Planning Board – April 23, 2018, 6:30PM
City Hall Council Chambers – 3 Washington Street, 2nd floor

AGENDA

SPR-01-18 Site Plan Review – Summit Athletic Center – 809 Court Street, Keene

SITE PLAN SET
THE SUMMIT ATHLETIC CENTER

SITE PLAN
TAX MAP LOT 188-01-001
809 COURT STREET
KEENE, NEW HAMPSHIRE
PREPARED FOR AND LAND OF:
HILLSBOROUGH CAPITAL, LLC
63 EMERALD STREET, SUITE 167, KEENE, NH 03431

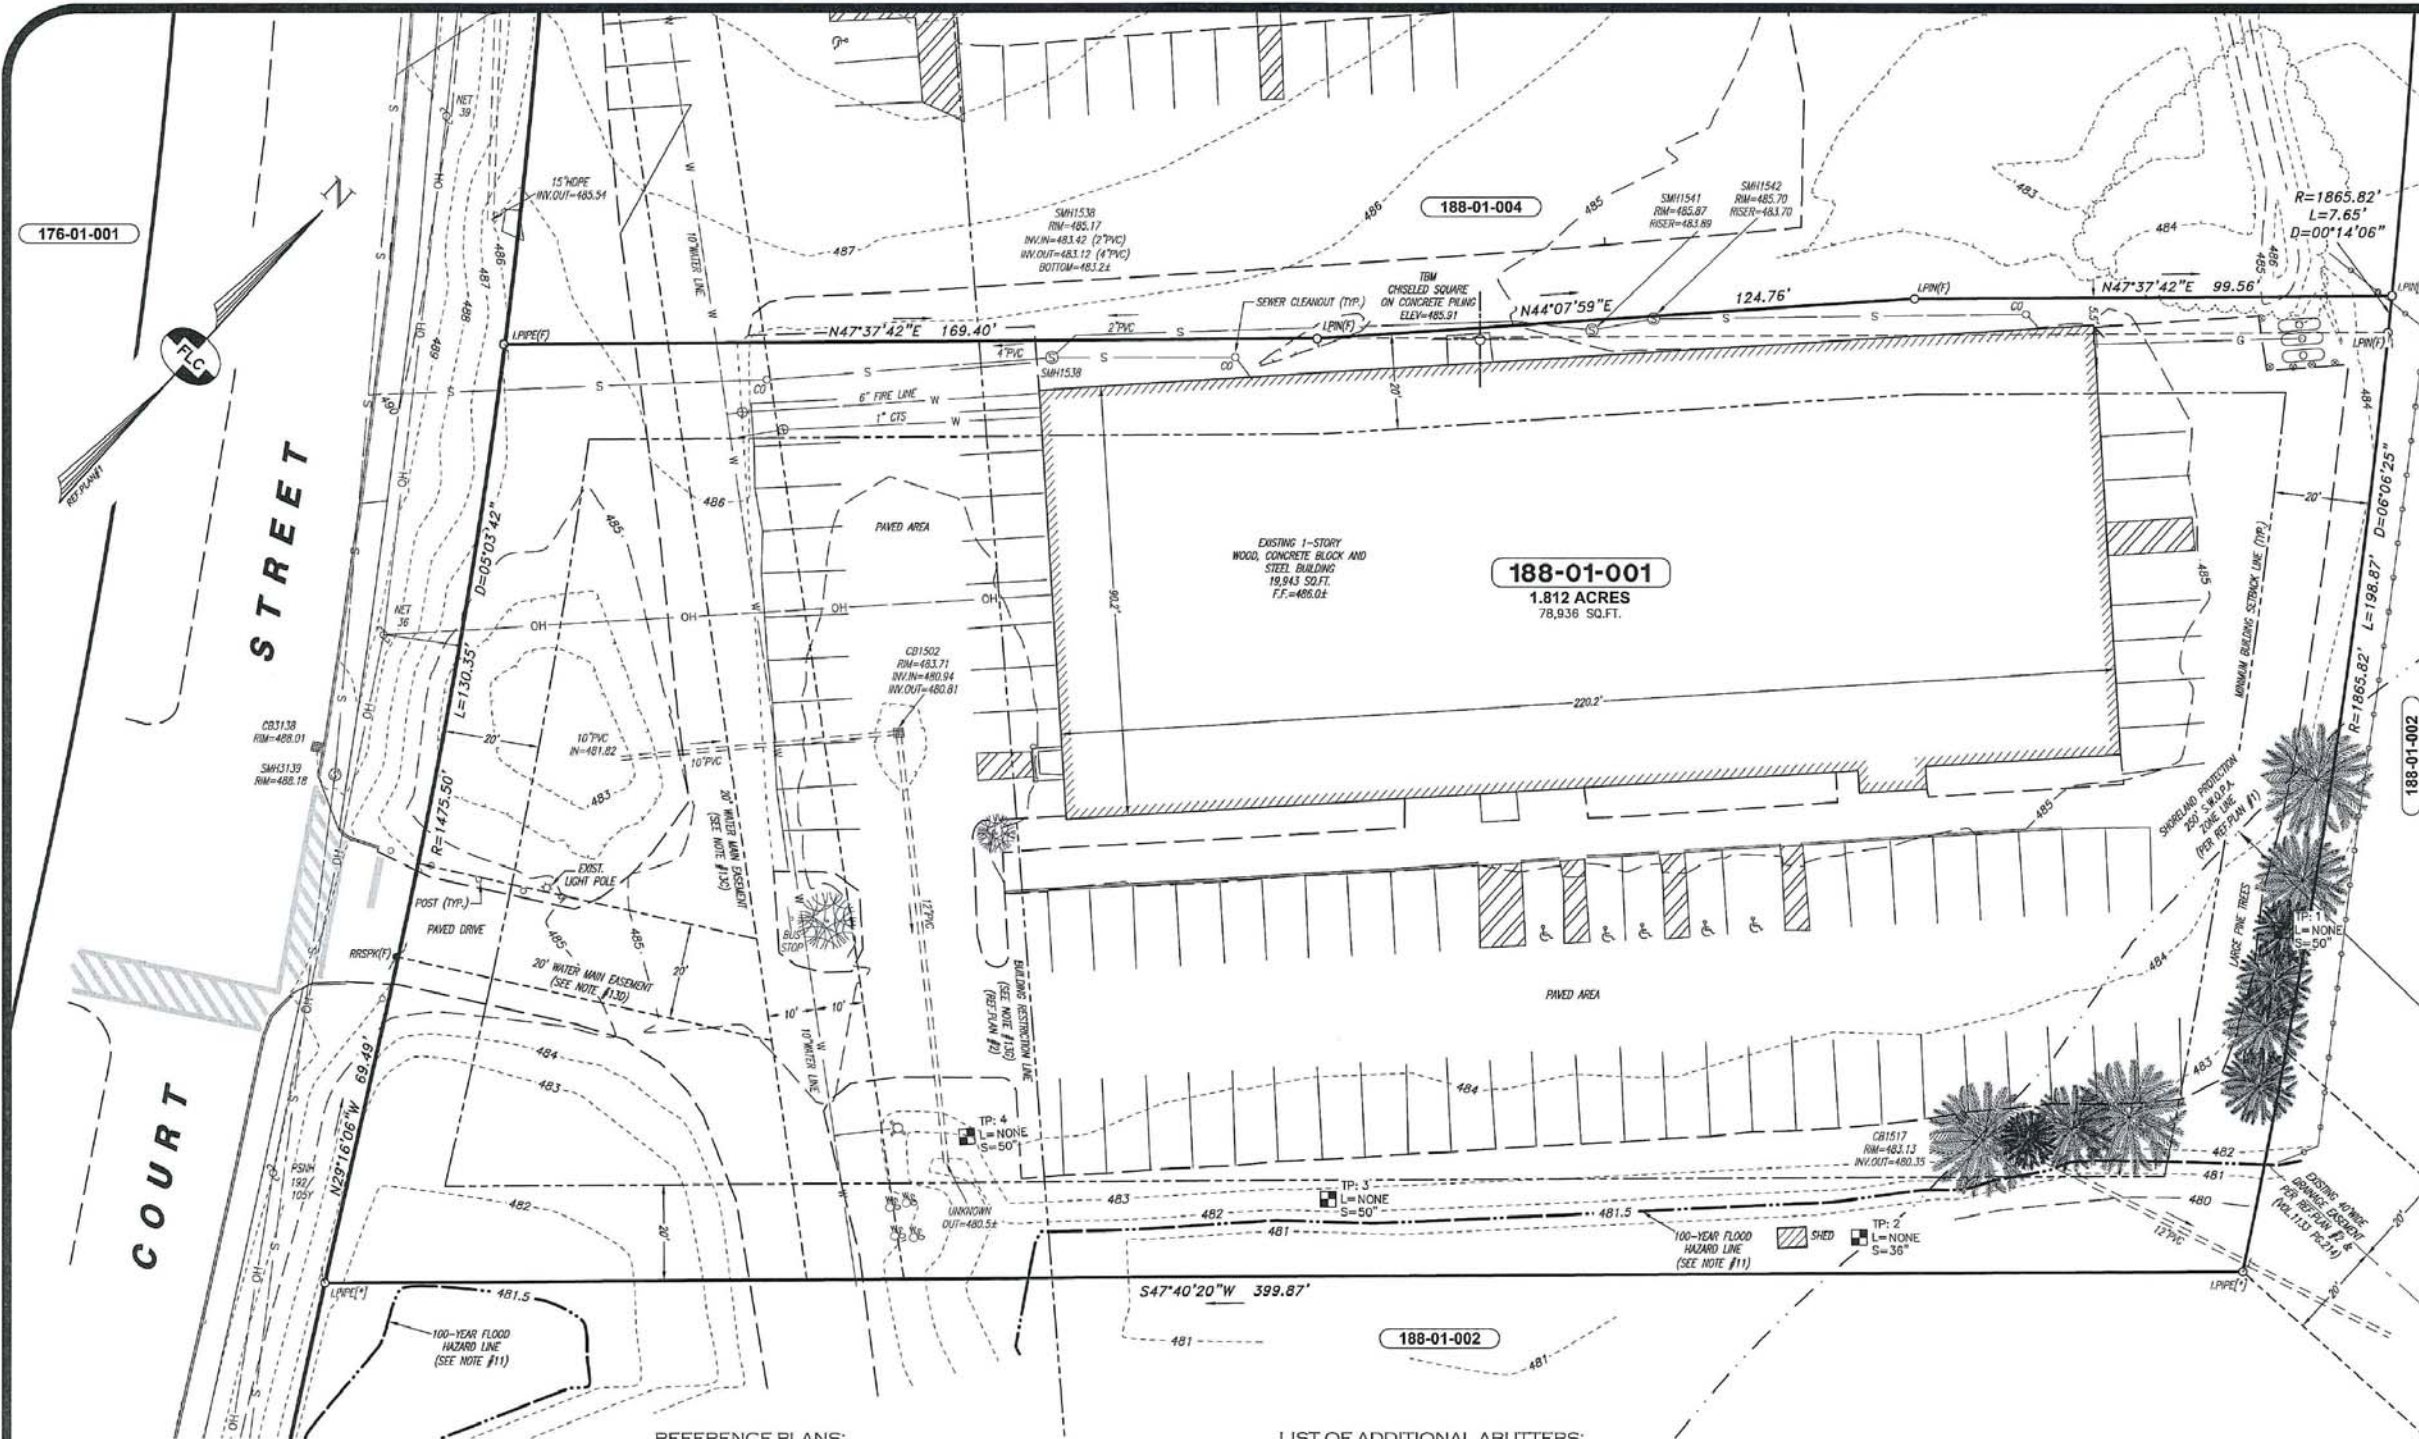
12. **Traffic:**
 - a. Per Planning Board Standard 12.c. As mentioned earlier, the revised site plan re-creates the interior and separate roadway allowing vehicular access from Court Street to the subject site as well as the adjacent properties. This new roadway is now 20' wide allowing two, 10' lanes for safer, two-way traffic. A new 4' wide, curbed island between this interior roadway and the front parking lot creates a stronger, physical separation between the roadway and the front parking area. The two areas are currently separated by sporadic concrete curb stops.

- b. Per Planning Board Standard 12.a. With regard to the proposed 4' wide curbed island, the current design shows this island as concrete. The Board may want to consider discussing the addition of

medium height shrubs within this 4' wide island for additional vertical separation and screening of car headlights in the parking lot. The growing conditions in this location would be severe and tolerated only by hardy plant species, for example, Chokecherry, Chokeberry, Beach Plum and/or Highbush Blueberry shrub varieties. A planting detail or note for the island would need to specify a slightly lower elevation within the center of the island, versus a common mounding practice, to allow for rainfall to access the plant material, providing a viable, long-term, growing condition.

13. Comprehensive Access Management: The revised site plan specifies a new sidewalk connecting the new building's front entrance to the existing Court Street sidewalk now through the middle of the property's frontage, with two painted crosswalks through the roadway and parking lot. This standard has been met.

- c. A revised Landscape Plan showing medium-height shrubs and shade trees in the 4' island with an appropriate planting detail to the satisfaction of the Planning Director.*

GRADING & UTILITY PLAN
TAX MAP LOT 188-01-001
809 COURT STREET
KEENE, NEW HAMPSHIRE
 PREPARED FOR AND LAND OF:
HILLSBOROUGH CAPITAL, LLC
 63 EMERALD STREET, SUITE 167, KEENE, NH 03431

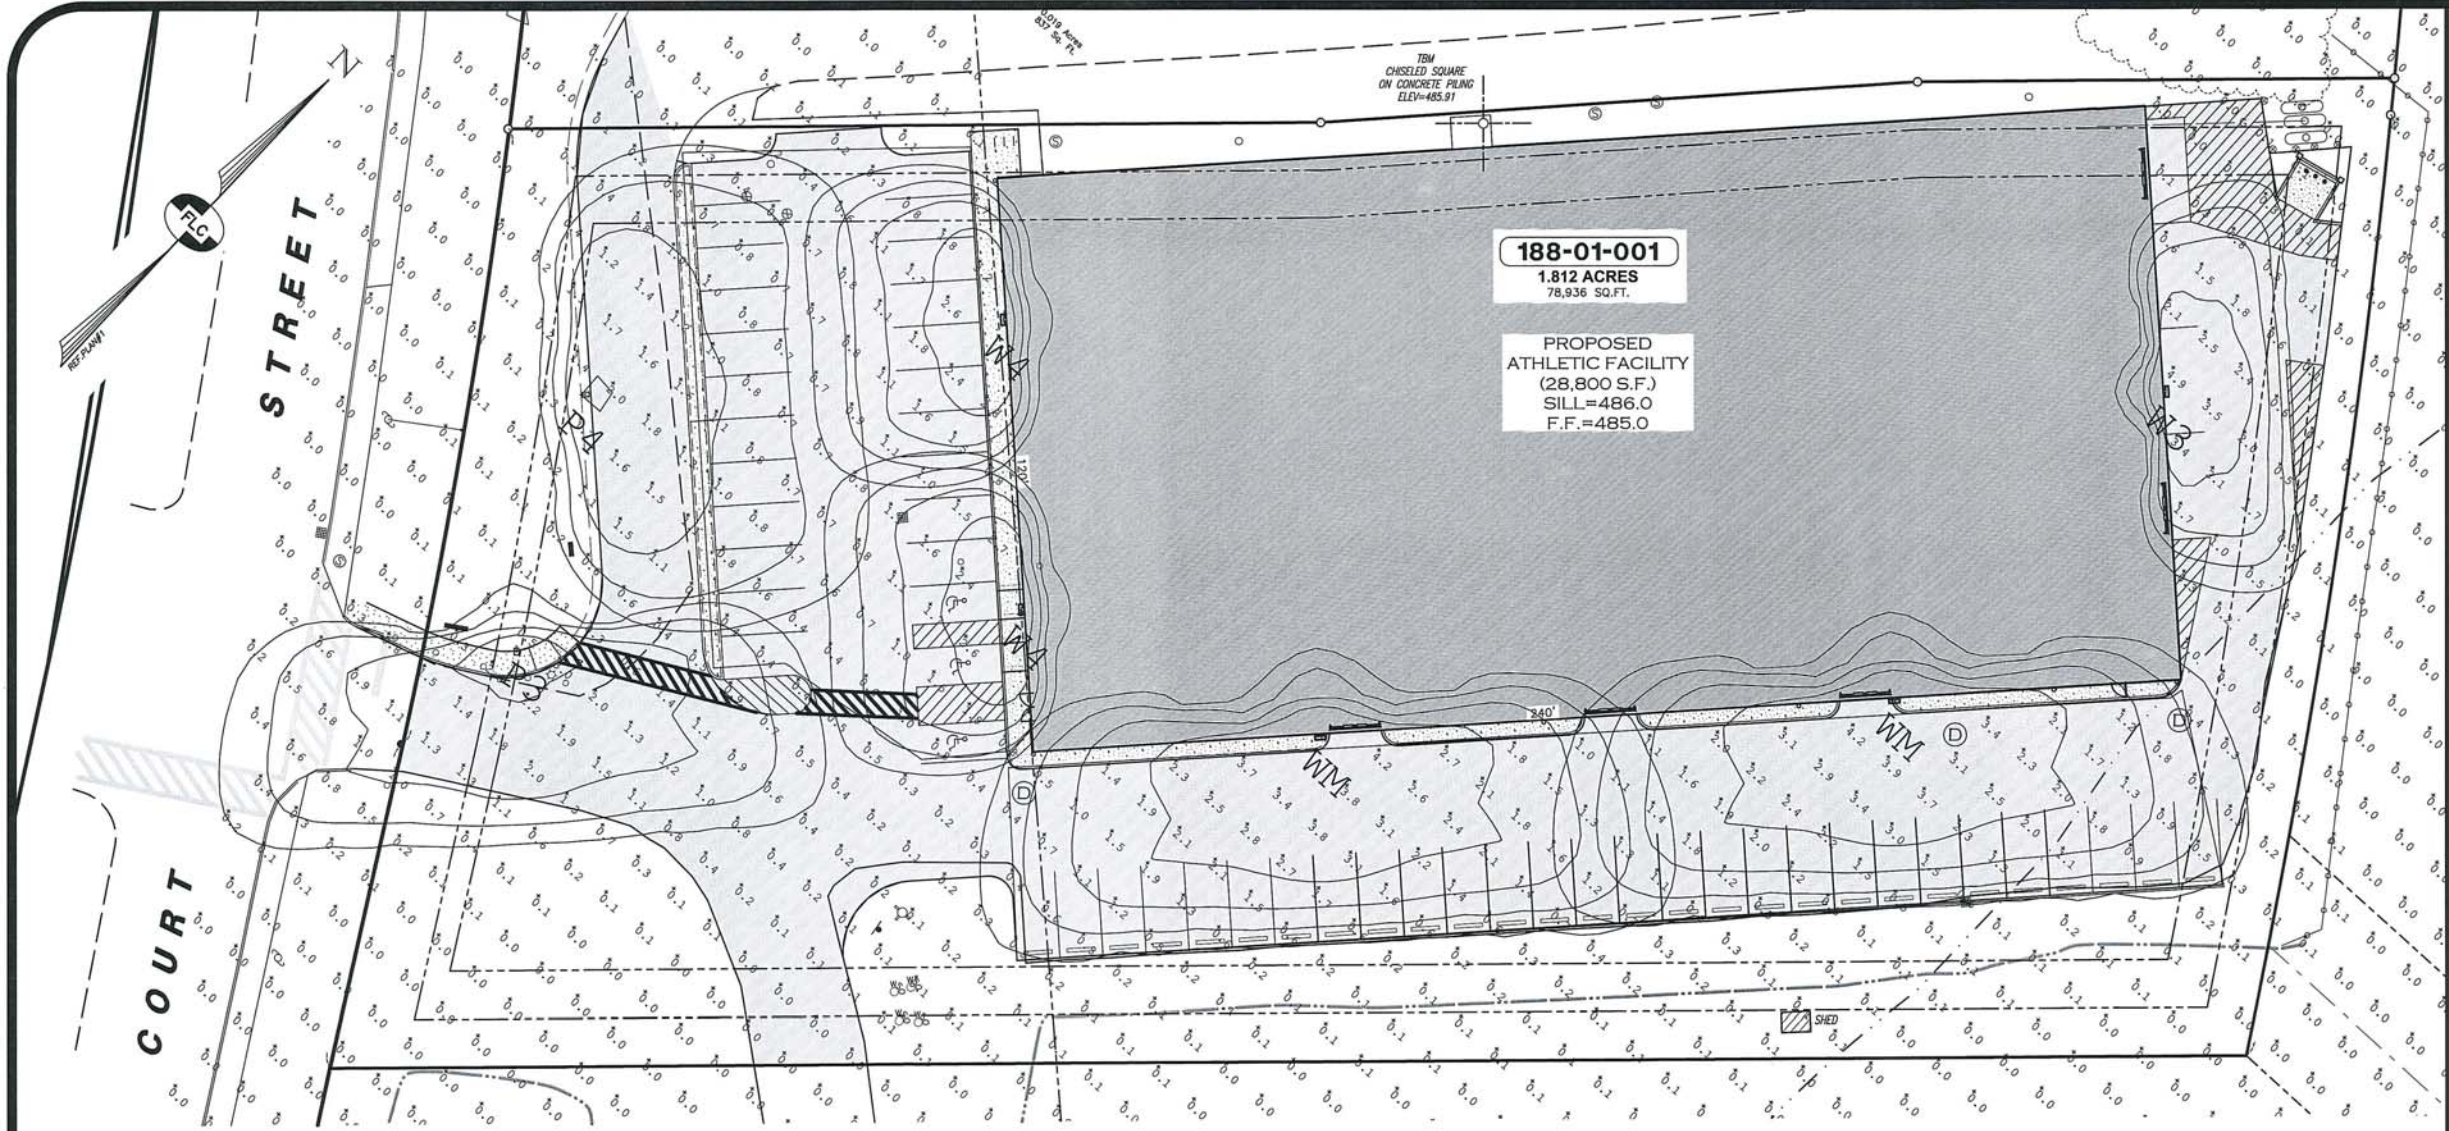
2. **Sedimentation and Erosion Control:** Per Planning Board (PB) Standard 2.b. The revised Grading and Utility Plan still specifies a silt fence encircling the disturbed areas of the site. Unfortunately, no location for a Temporary Construction Entrance is shown on the revised plan. A condition to add this to the Grading-Utility Plan is included in the recommended motion. This is due to the construction site's close to the Ashuelot River and the predominant grade decrease along Court Street toward the river's bridge abutment.

- b. A revised Grading-Utility Plan drawing showing the location of a Temporary Construction Entrance at or before the building demolition and excavation work area, to the satisfaction of the Planning Director and City Engineer.*

LIGHTING PLAN
TAX MAP LOT 188-01-001
809 COURT STREET
KEENE, NEW HAMPSHIRE
 PREPARED FOR AND LAND OF:
HILLSBOROUGH CAPITAL, LLC
 63 EMERALD STREET, SUITE 107, KEENE, NH 03431

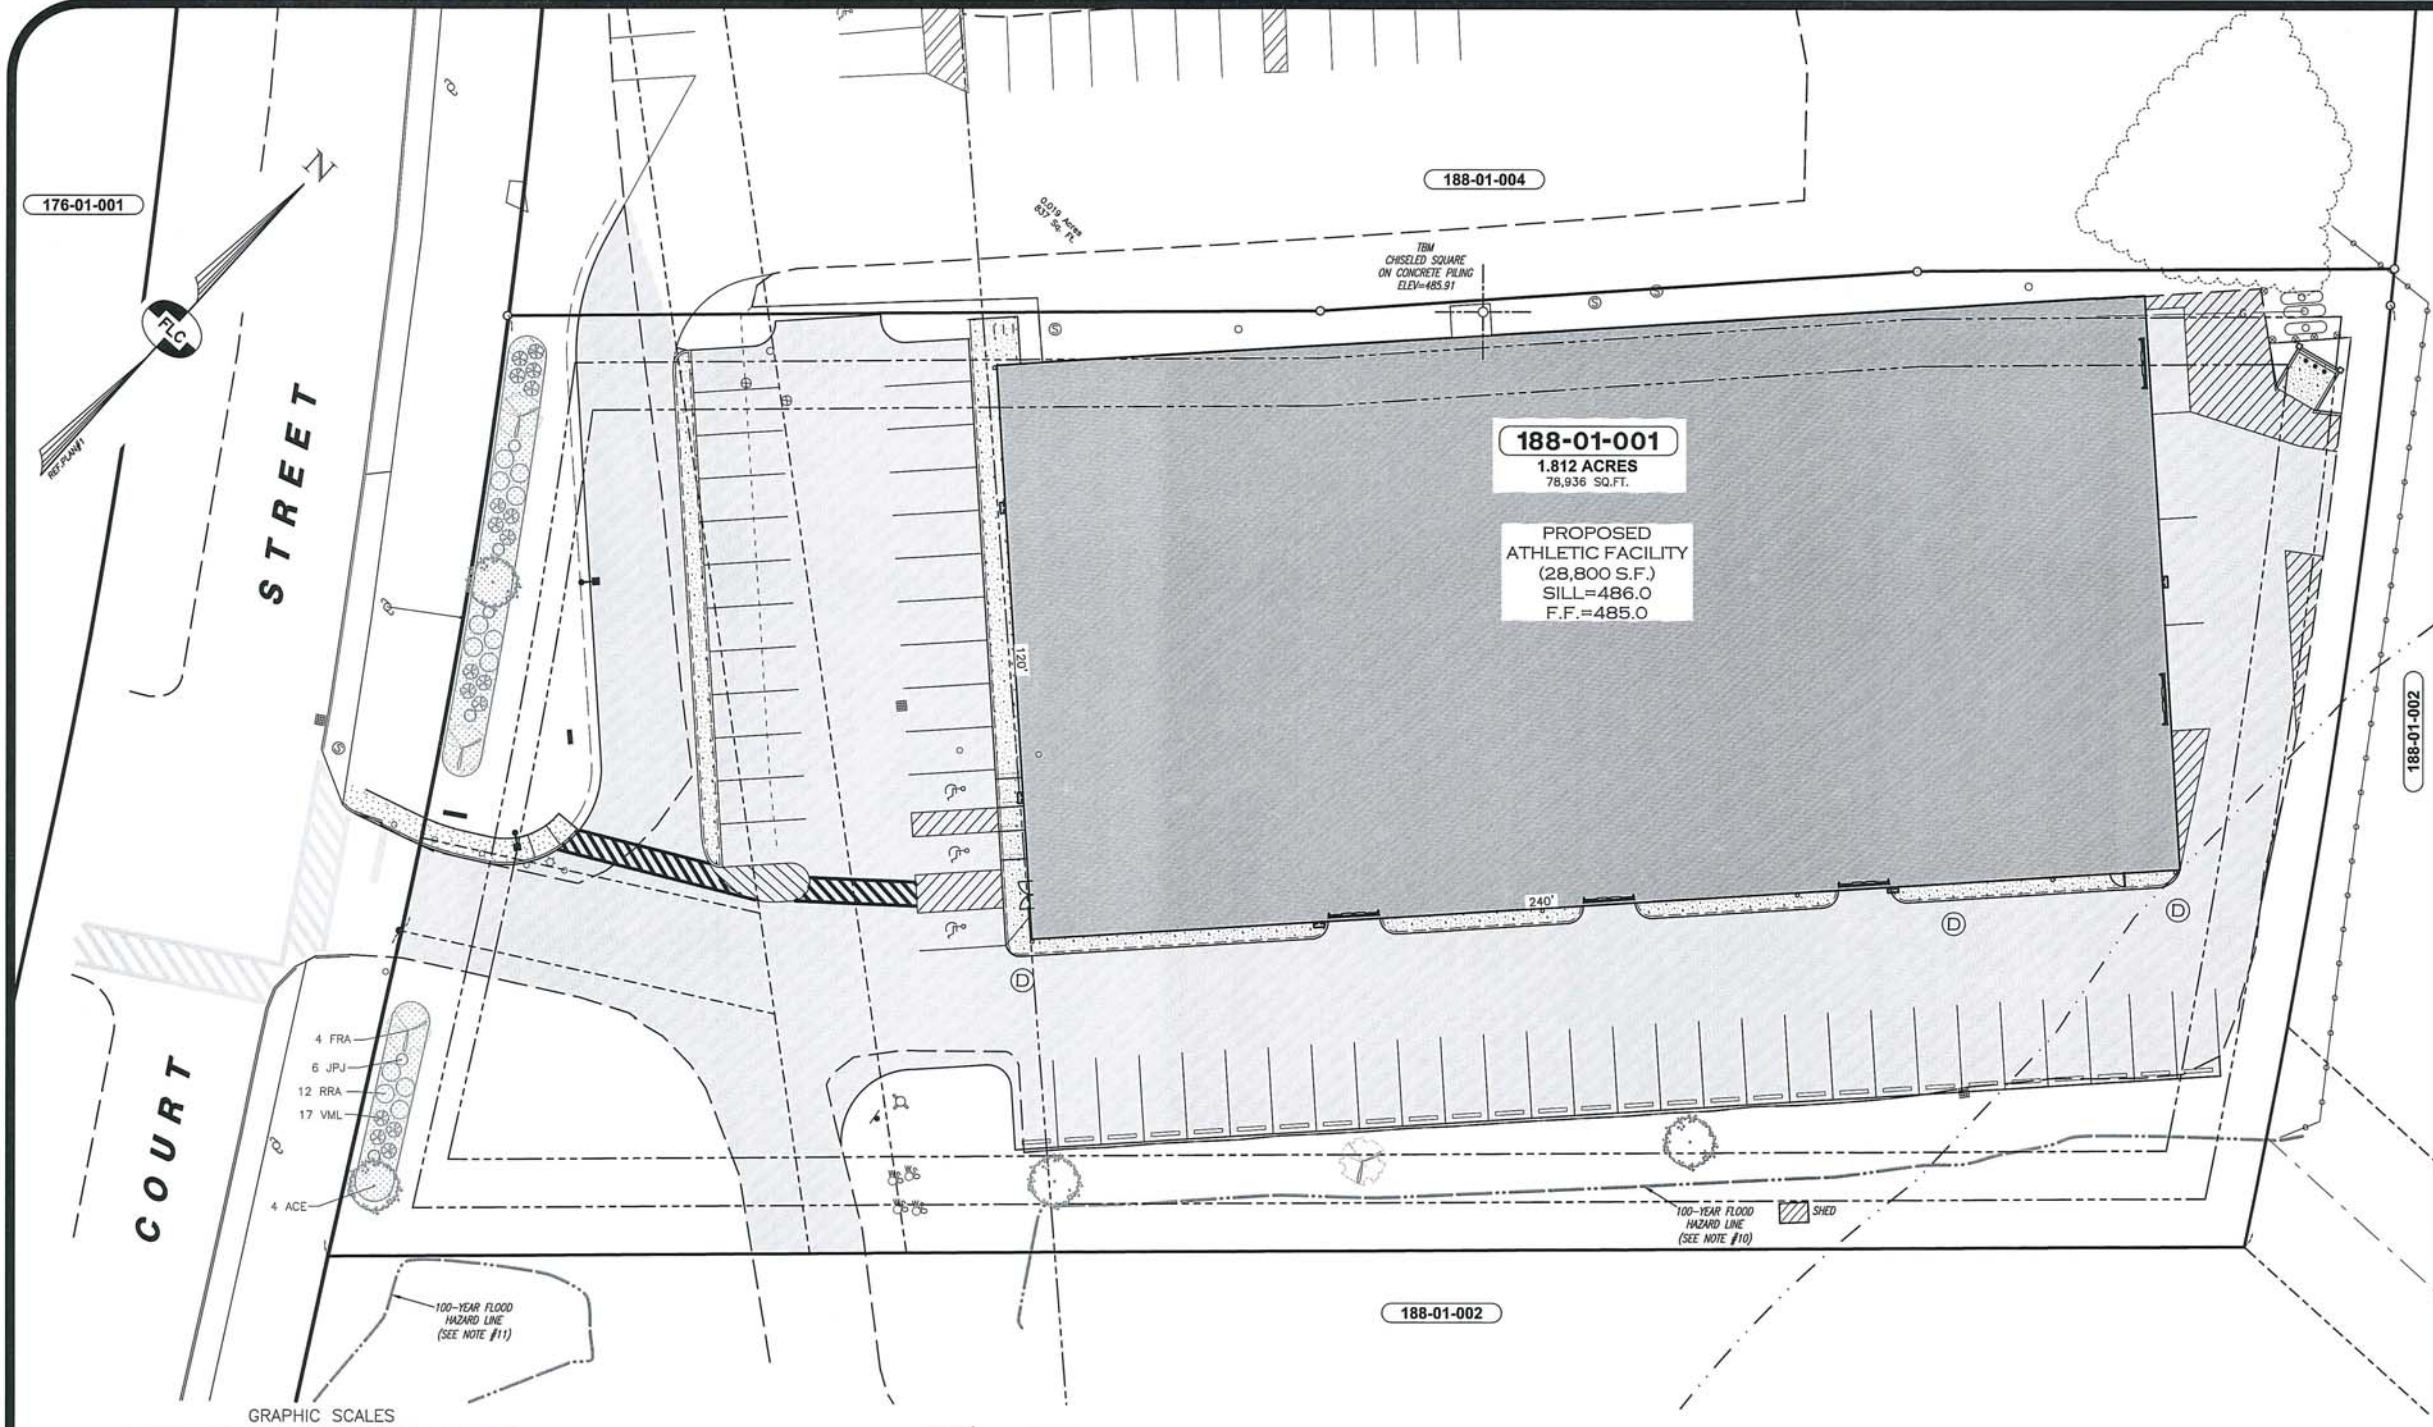
10. **Lighting:** The revised site plan now specifies two pole fixtures providing adequate light with compliant fixtures for the site's entrance area and the new sidewalk/path of travel to the building. This standard has been met.
